## ANN ARBOR HISTORIC DISTRICT COMMISSION

### Staff Report

**ADDRESS:** 706 W Liberty Street, Application Number HDC25-0094

**APPLICATION:** The applicant seeks HDC approval to remove a post-1945 two-story addition at the rear of the house and then construct a new two-story rear addition, plus a one-story rear addition and a rear deck.

**SIDE ELEVATION (EAST) - PROPOSED**  
SCALE: 1/8" = 1'-0"

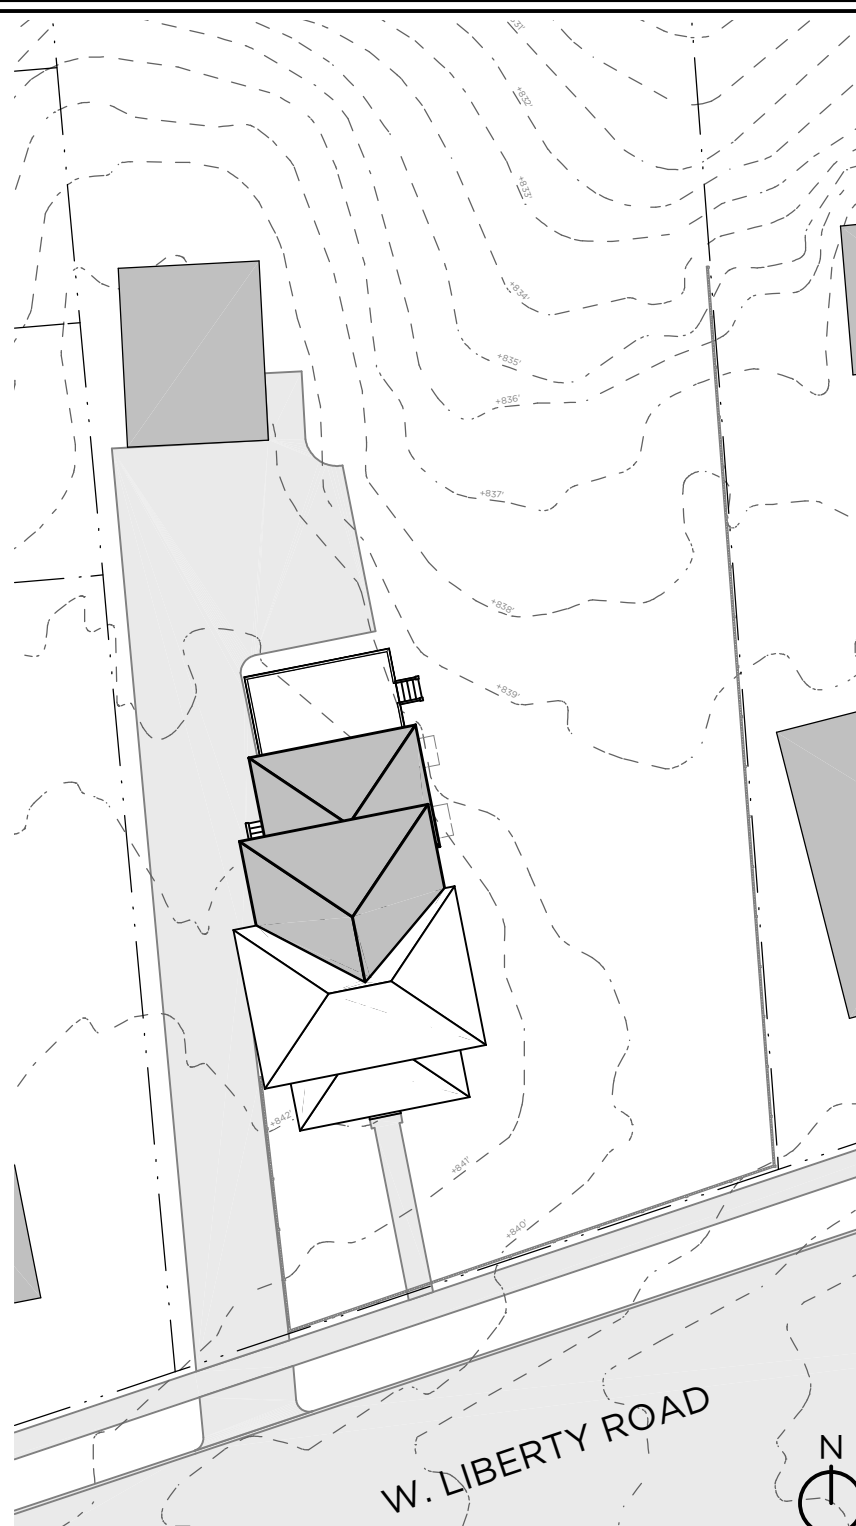
The two-story addition is inset one foot from the historic house on the east side. This is an improvement over the current condition, where the addition is in the same plane as the historic east wall. It is also inset on the west side, but the dimension is not labeled on the drawings. It appears to be more than one foot. The east side of the one-story portion aligns with the east elevation of the two-story addition portion, with a small bumpout to accommodate a fireplace. The west elevation of the one-story portion is inset 4 feet 6 inches from the west side of the two-story portion.

There will also be two egress window wells on the east side of the additions.

9. Included as part of the application are new mechanical units on the east side of the two-

story portion of the addition, at the rear of the historic house. This is an appropriate location for mechanical equipment.
